JTB00542NAS1

TECHNICAL BULLETIN

Oil Leak From Transmission Threaded Boss

MODEL:	MODEL YEAR:	VIN:	ASSEMBLY PLANT:	APPLICABILITY:
XE (X760)	2016- 2017	900000- 942577	Solihull	Vehicles With: 8HP45 8-Speed Automatic Transmission RWD
XF (X260)	2016- 2017	Y00001- Y27214	Castle Bromwich	Vehicles With: 8HP45 8-Speed Automatic Transmission RWD

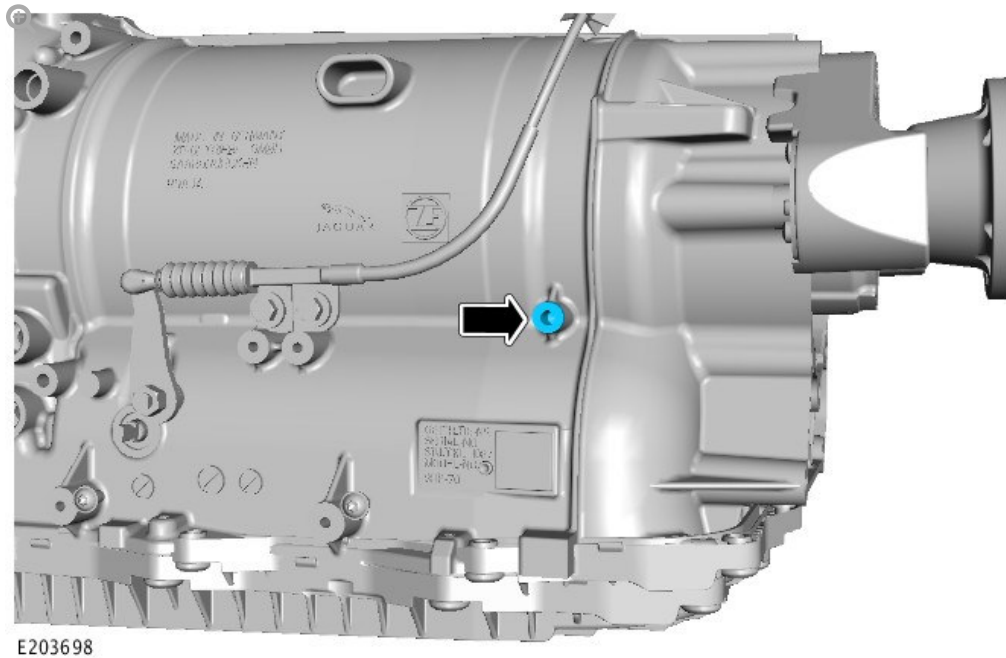
An oil leak from the underneath of the vehicle may be evident. Upon further inspection, the oil leak appears to be coming from the transmission threaded boss.

This may be caused by thermal expansion between the transmission aluminum casing and the embedded steel tube, causing the threaded boss area to become porous.

- 1 If the oil leak is not from the area shown, do not continue with this Service Instruction.
 - Continue diagnosis using the TOPIx Workshop Manual.
- 2 If the oil leak is from the area shown, go to Step 3.

3 Apply Loctite® 542 or equivalent to the new grub screw.

Install the new grub screw.

- Torque: **10 Nm.**
